Department of Energy  
Washington, D.C. 20545

Docket No. 50-537  
HQ:S:82:032

RESPONSES TO REQUEST FOR ADDITIONAL INFORMATION - AUXILIARY SYSTEMS

Reference: Letter, P. S. Check to J. R. Longenecker, "CRBRP Request for Additional Information," dated March 15, 1982

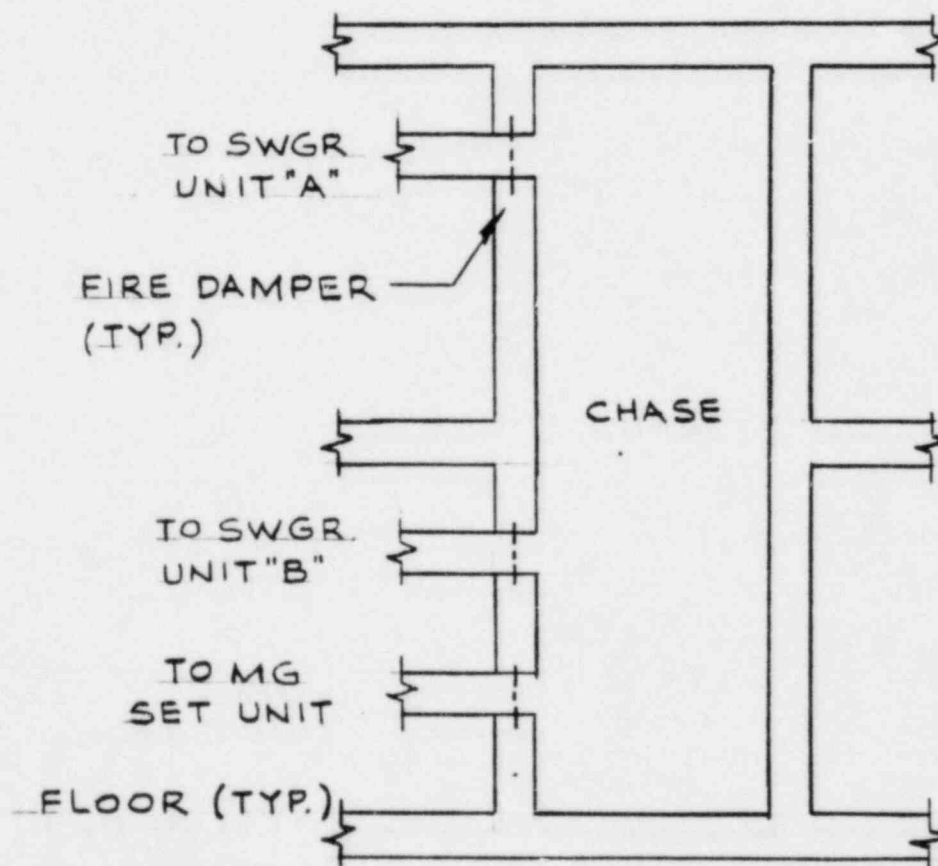
Question 410.8 (9.6.1)

On Figure 9.6.3 indicate the interface between the safety-related switchgear room HVAC air intake ducting and the non-safety-related MG set HVAC subsystem air intake ducting.

Response

The outside air intake shown on Figure 9.6-3 is a schematic representation of a 3 hour fire-rated chase. This intake and chase is shown on Figures 1.2-70 and 1.2-71. Individual intake ducting is provided for each HVAC unit and is connected to the intake chase. Each opening into the intake chase is protected by a 3 hour rated fire damper. The interface between safety-related switchgear room HVAC intake ducting and non-safety related MG set HVAC intake ducting is the chase as shown below.
